HISTORIC AND DESIGN REVIEW COMMISSION

HDRC CASE NO: 2018-335
ADDRESS: 242 KING WILLIAM
LEGAL DESCRIPTION: NCB 740 BLK 3 LOT NW 133.7 FT OF 22 & NW 133.7 FT OF SW 27.5 FT OF 10
ZONING: RM-4 S,HE
CITY COUNCIL DIST.: 1
DISTRICT: King William Historic District
LANDMARK: Sanger House
APPLICANT: Len Ambrosio and Timothy Ziegel
OWNER: Len Ambrosio and Timothy Ziegel
TYPE OF WORK: Front Yard Fencing
APPLICATION RECEIVED: July 02, 2018
60-DAY REVIEW: August 01, 2018
REQUEST:

The applicant is requesting a Certificate of Appropriateness for approval to install a new fence featuring low masonry wall and columns with wrought iron fencing.

Fence height dimensions

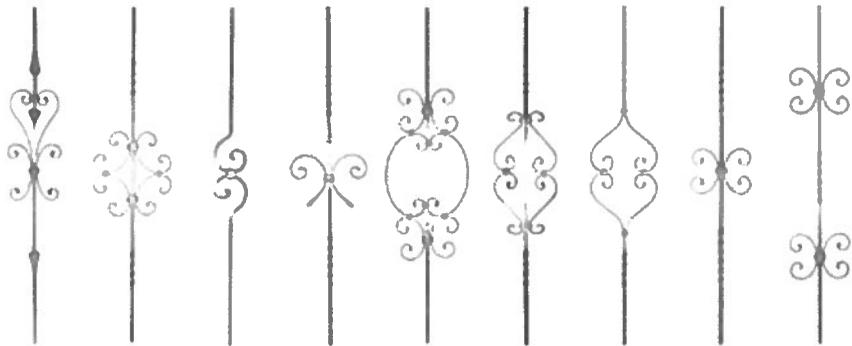
- i. A final measured drawing that accurately depicts the proposed fence be submitted to staff (specifically the total height from grade, the height and materials of the stucco/masonry base, and the exclusion of extra front steps or grade changes).
- ii. Every effort should be made to match the fence masonry columns to the masonry of the historic structure in color, size, and texture.
- iii. No portion of the fence is to exceed 4ft in height in the front yard and 6ft in the rear yard, defined by the front façade plane of the structure.

242 King William Property Fence Limits

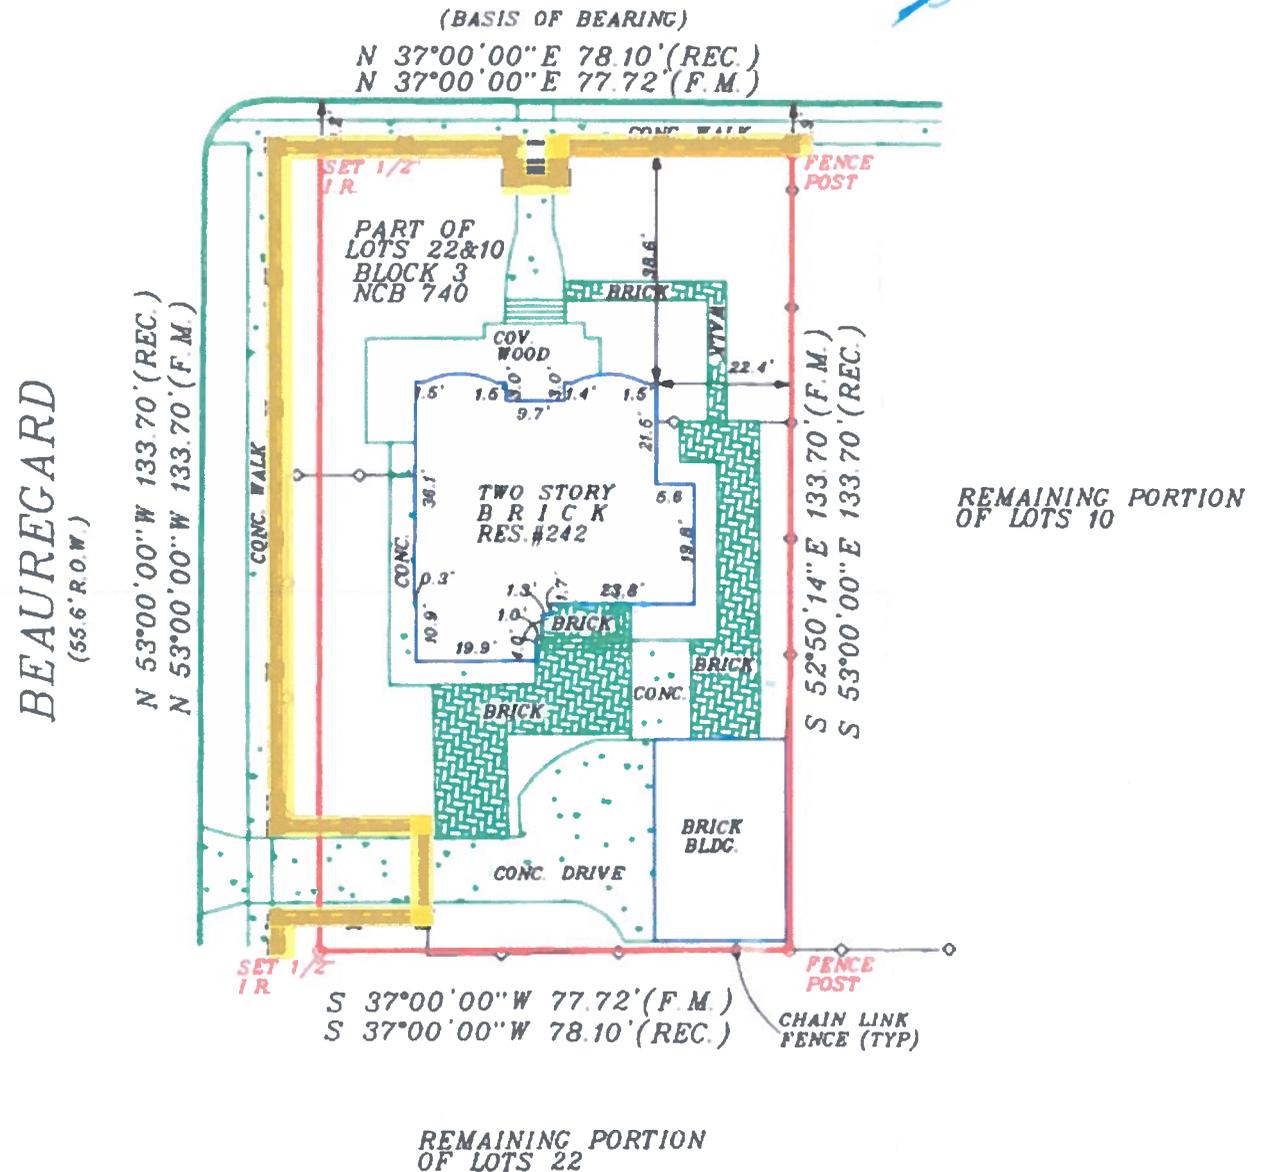
- b. FENCE LOCATION – The applicant is requesting to install a fence spanning across the front yard and turning at the corner to meet the existing chain link fence in the rear. According to the Guidelines for Site Elements 2.B.ii, new front yard fences should not be introduced within historic districts that did not historically. Staff finds that fences are found on King William St and within the King William Historic District. Staff finds the proposed location and configuration of the new fence appropriate.
